**REGULAR MEETING OF THE  
CITY OF CONCORD  
PLANNING COMMISSION**

**REPORT TO PLANNING COMMISSION**

This study session is intended to provide the Planning Commission an opportunity to discuss the proposed Chalomar Crossings rezoning and subdivision and to provide direction to staff and the applicant regarding the applicant's proposal, degree of consistency with the Development Code requirements, and compatibility with the existing neighborhood, prior to a Final meeting at the Design Review Board. Any recommendations by the Planning Commission are intended for incorporation into plans by the applicant, prior to Final Design Review.

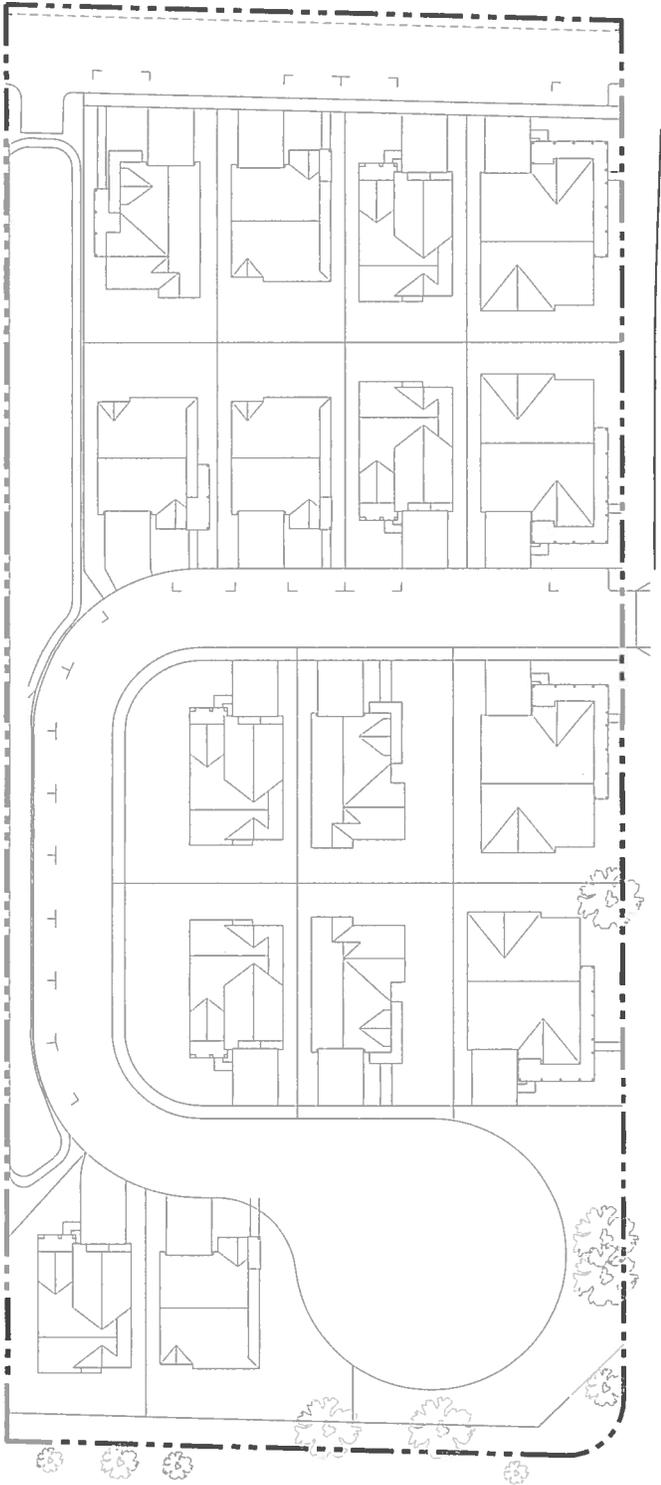
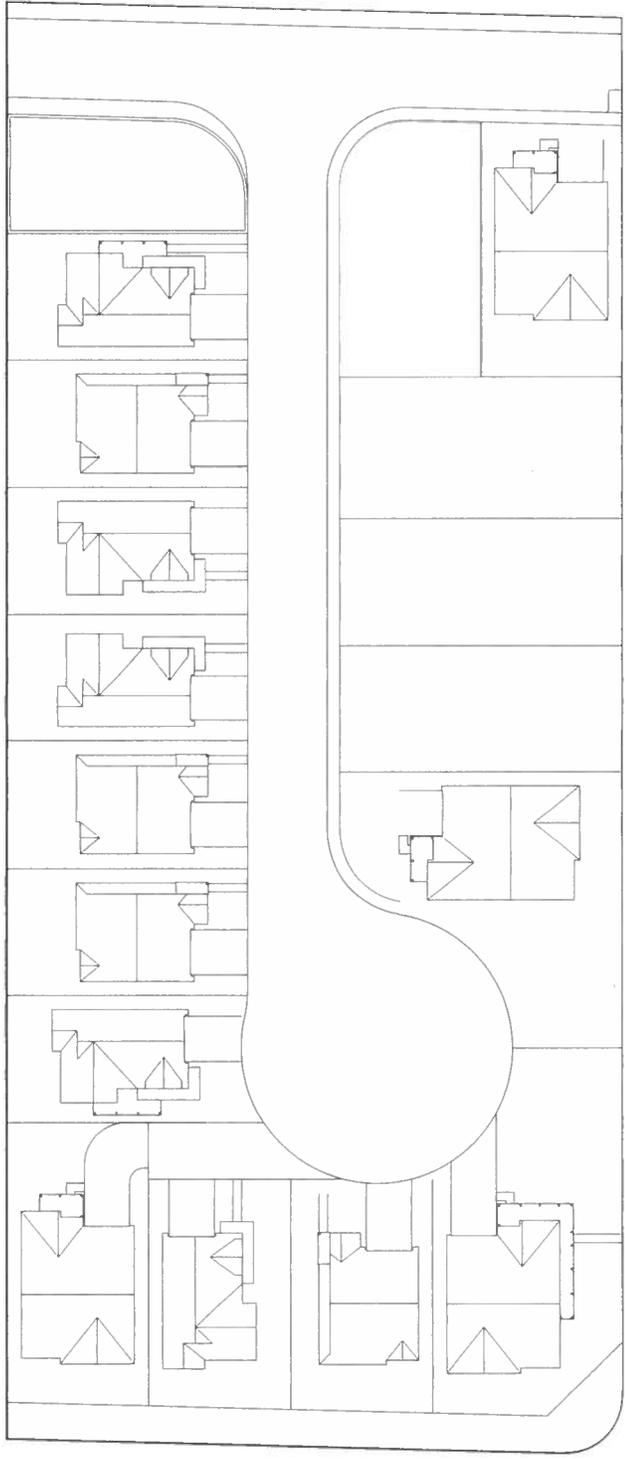
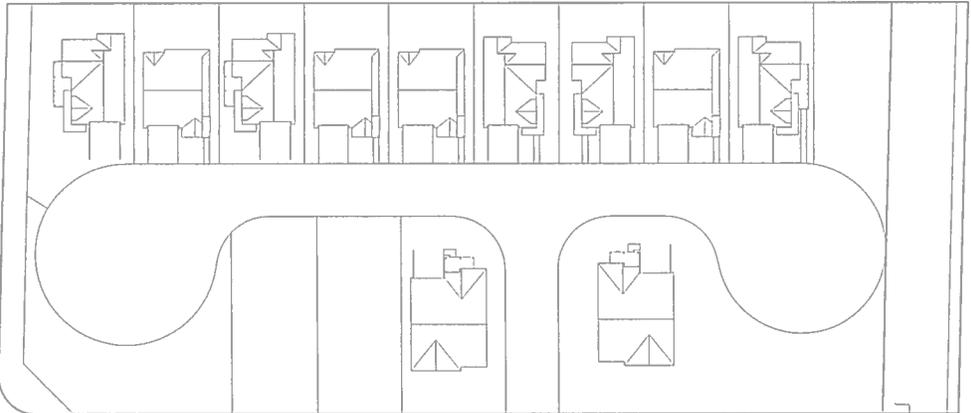
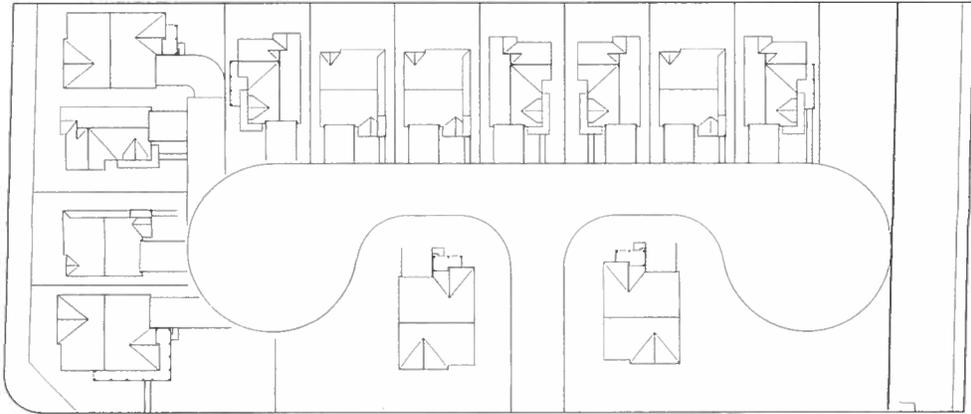
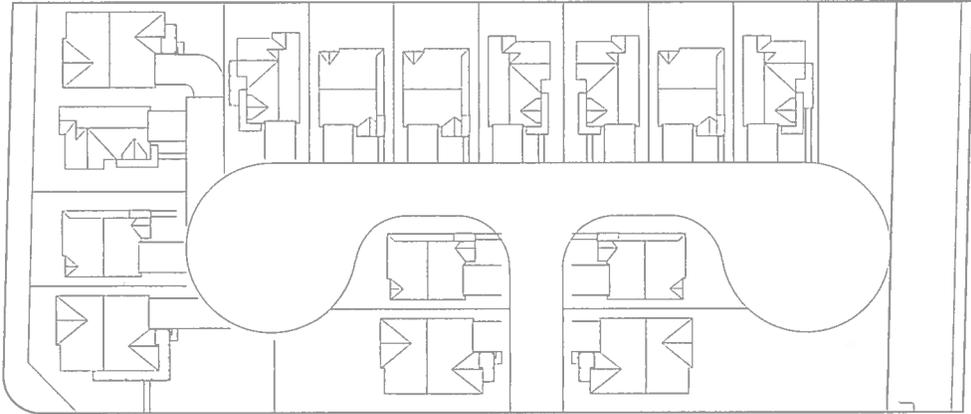
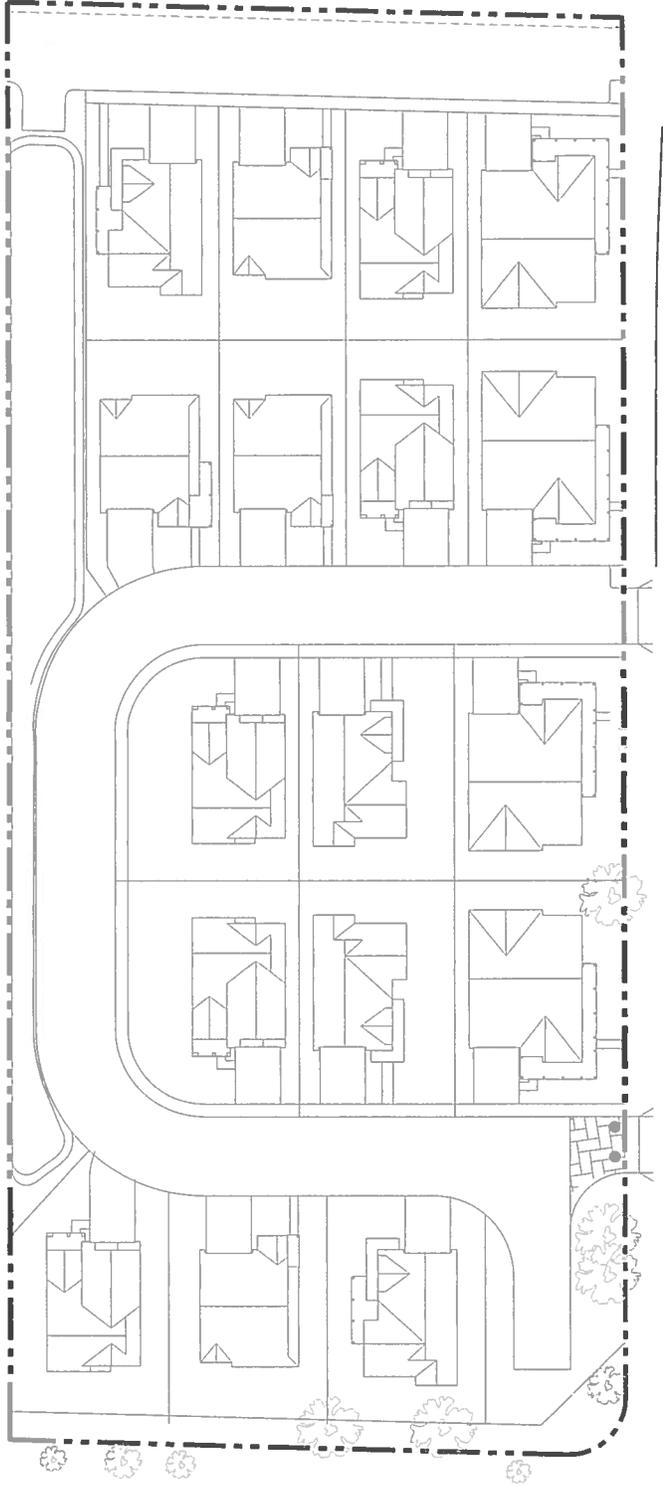
On July 9, 2015, the Board held a fourth meeting to review four site plan concepts submitted by the applicant, numbered as #19-22, with alternative #21 having three options (Exhibit D). The Board suggested it may be possible to have a site plan with just one connection to Chalomar Road that does not utilize the easement area for primary access, and encouraged the applicant to revisit this issue. Staff suggested the applicant discuss site plan alternatives with the Fire District. The Board encouraged the applicant to return with modifications looking at #20/#21 (top option), showing a new access point to Chalomar Road, further from Oak Grove Rd. corner, but with an EVA egress point.

# CONCEPT #25

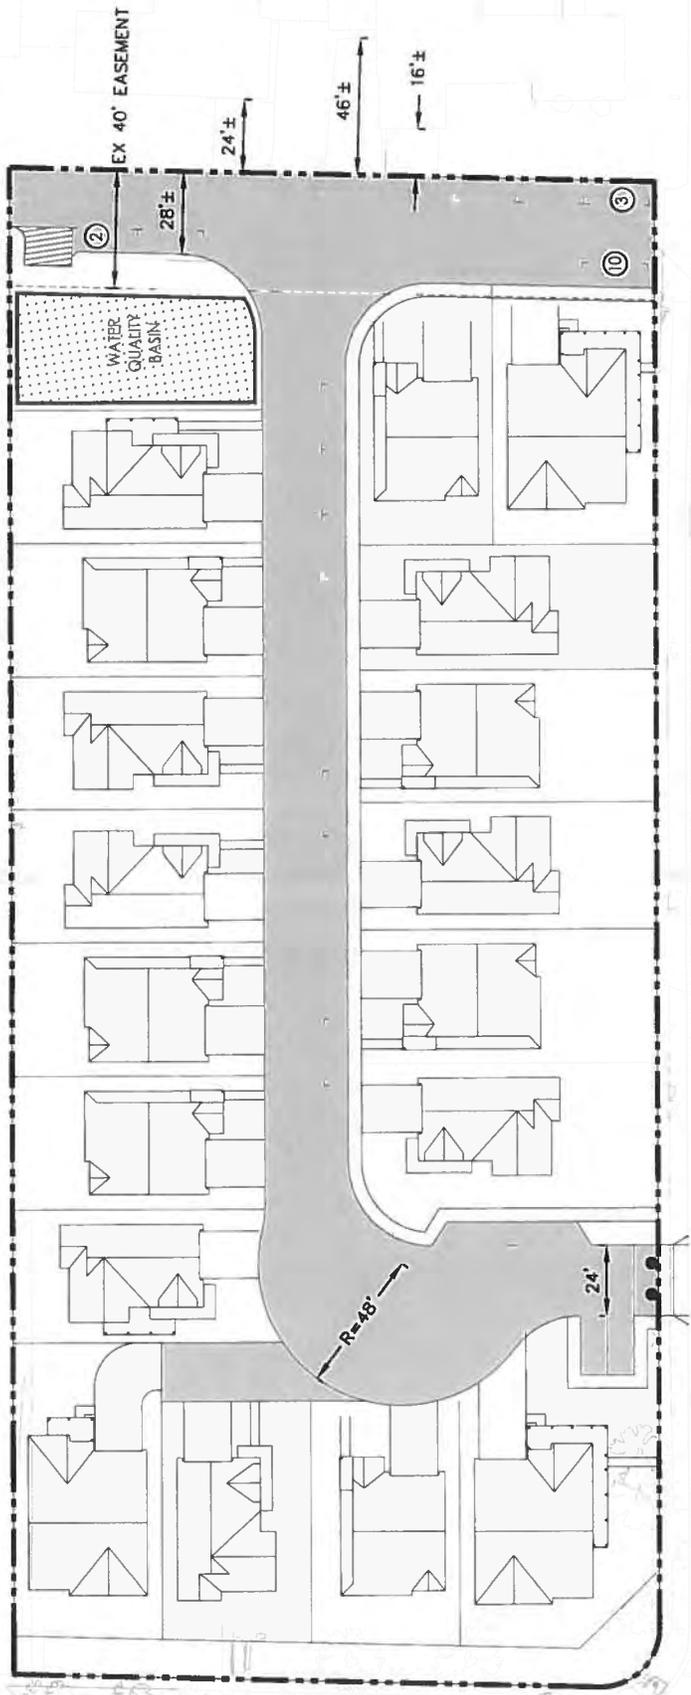
On August 13, 2015, the applicant returned for a fifth meeting with the Board presenting Alternatives 24 and 25 (Exhibit E). The two site plan layouts differed primarily in that Alternative 24 provided primary access from Chalomar Road and Alternative 25 provided primary access from the eastern easement. Alternative 24 placed entries to (single story) units along Chalomar Road allowing for more on-street parking (25 spaces), while Alternative 25 was oriented such that rear fences of units faced Chalomar Road and provided only 15 parking spaces. The Board concluded that Alternative 24 had more benefits, but that additional variations should be explored. During the meeting, Planning staff indicated to the Board that the project is planned for a Planning Commission study session on September 17, 2015 for discussion of issues including density, traffic and circulation, interface to the neighborhood and other related issues, so that the Commission could provide staff, the DRB and the applicant further direction on the project.

Project Site Plan (Concept #24)

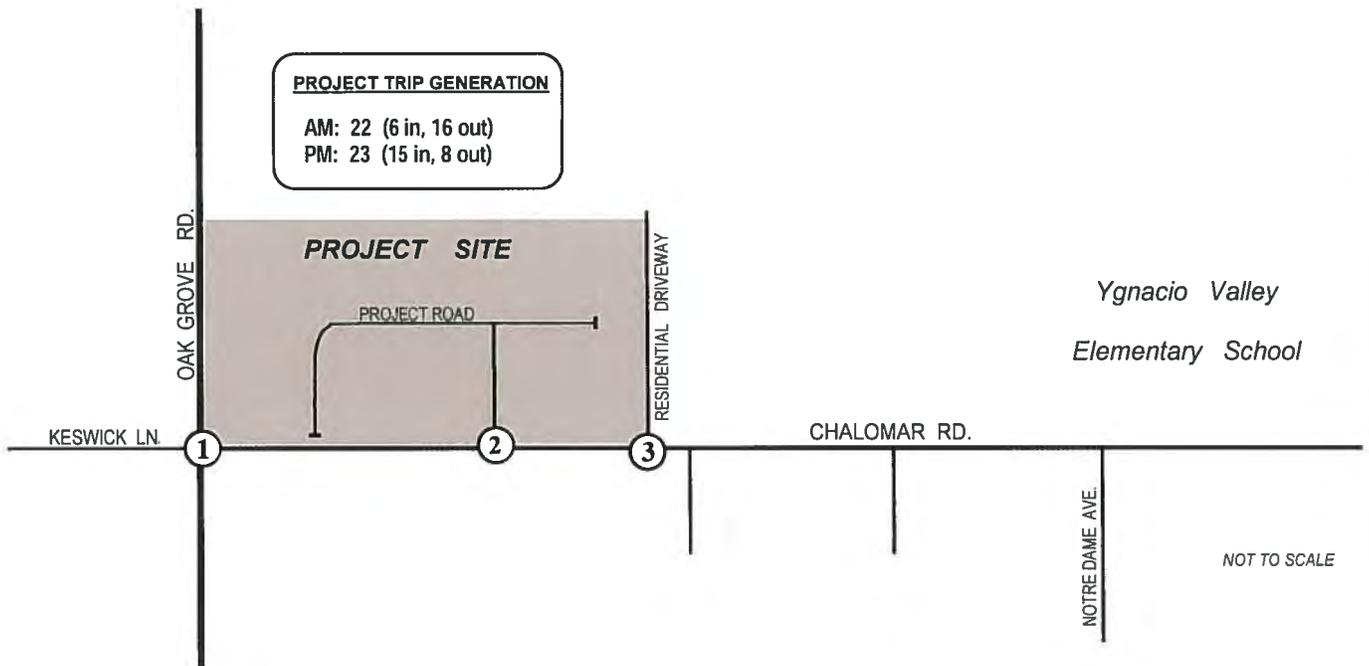
*The project site plan has evolved through a number of meetings with the Design Review Board and Alternative 24 is the latest site plan with the most support of the Board (Exhibit E), reflecting two access points at Chalomar Road. The plan includes 28-foot wide private streets accommodating parking on one side of the road consistent with Section 17.35.190 (g)1c of the City’s Subdivision Ordinance and a 4-foot sidewalk on one side of the road. The sidewalk would tie into the existing sidewalk along Chalomar Road. The plan proposes 25 on-street parking spaces within the project site. Eleven additional on-street parking spaces are shown on Chalomar*

During the conclusion of the applicant's last meeting, the Board voiced a desire to explore this plan further to examine extending the roadway east to connect to the easement area for a second access point or alternatively to remove the western access point between Lots 13 and 17.

*Alternative 24 reflects two entry points along Chalomar Road, one serving 16 units and one serving two units in addition to three existing units. An Emergency Vehicle Access (EVA) from the subdivision to Chalomar Road has been located further west on the site toward the intersection of Oak Grove Road. As discussed earlier, 28-foot private roadways would provide access to the site along with a 4-foot sidewalk that would connect to the sidewalk along Chalomar Road. The City's benchmark of Level of Service (LOS) D is required for intersection operations outside of the downtown area.*

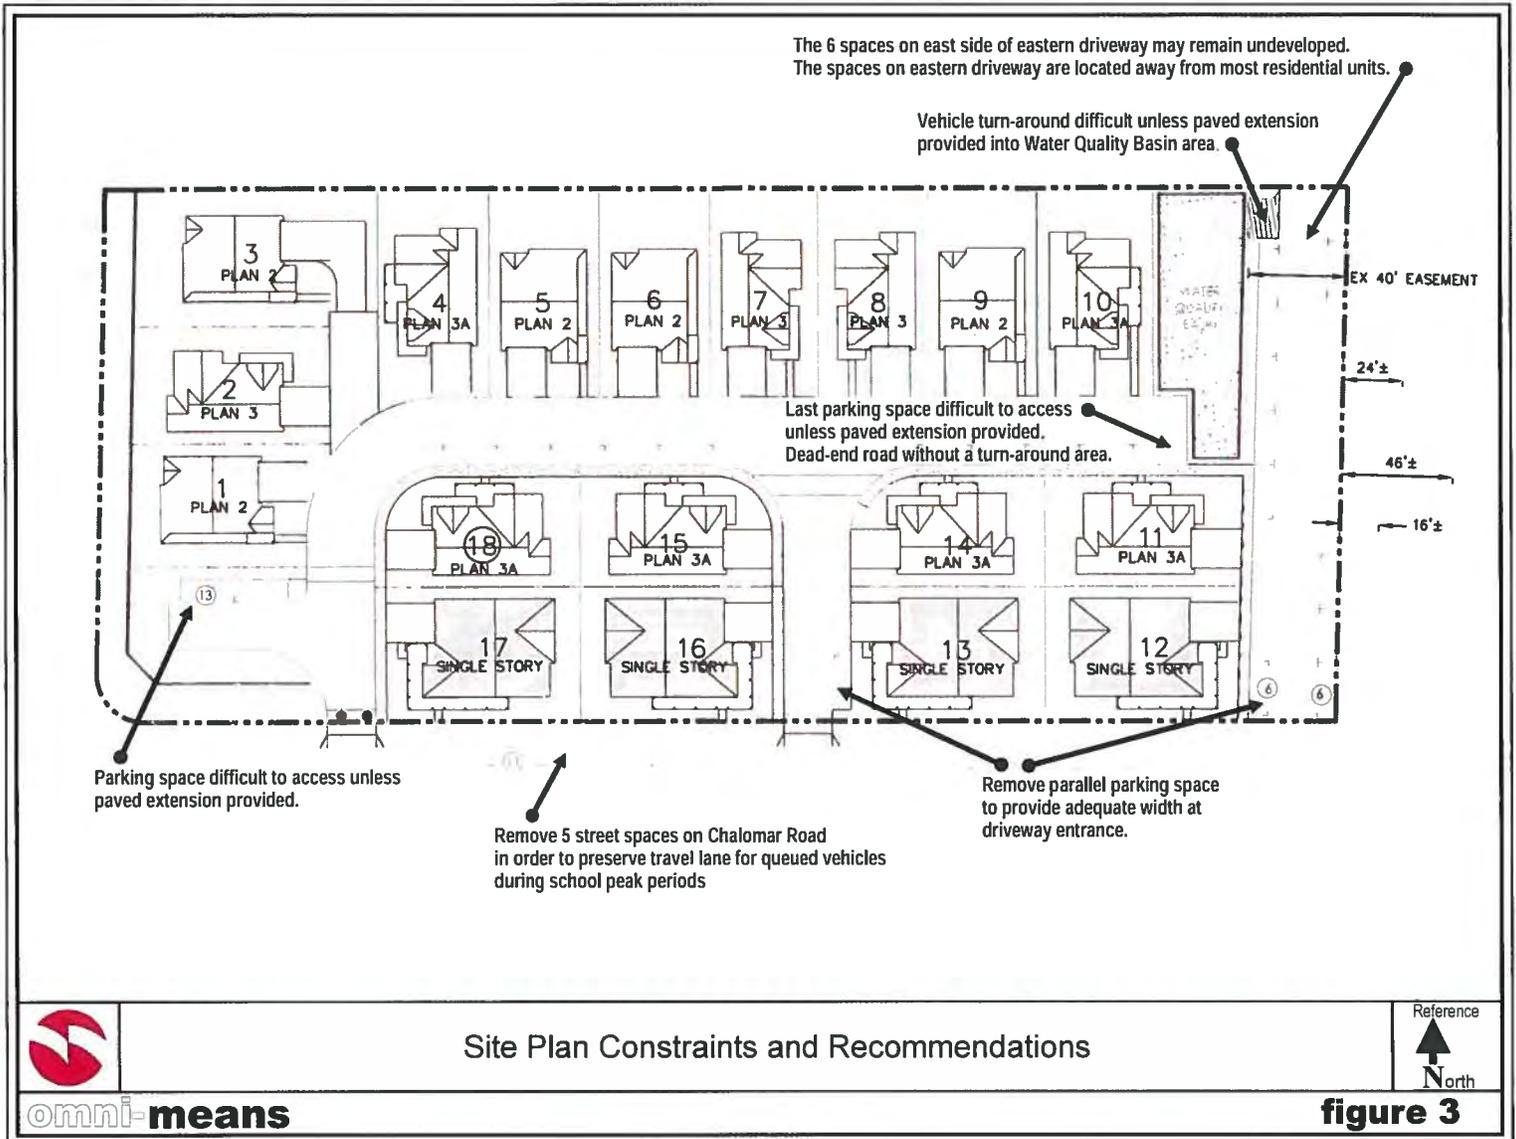
A review of the revised site plan indicates several of the onsite parallel parking spaces would likely require removal or be unusable due to access constraints. A description of the spaces is listed as follows and is illustrated in Figure 3:

As noted above in the parking discussion, the revised site plan shows the internal access road dead-ends at the Water Quality Basin boundary without a turn-around area. Although traffic volumes would be low on this segment of the internal road (vehicles accessing only 2 or 3 units), the lack of a turnaround area and a potentially inaccessible parking space at the end of the road is less than ideal for traffic circulation purposes.

Also, the parallel space in the northwest corner of the eastern driveway appears to have a paved extension behind (north) of it. However, this area will also have to serve as a turn-around area for vehicles. In order to facilitate vehicles turning around, the paved area would have to be expanded to the west into the Water Quality Basin area.
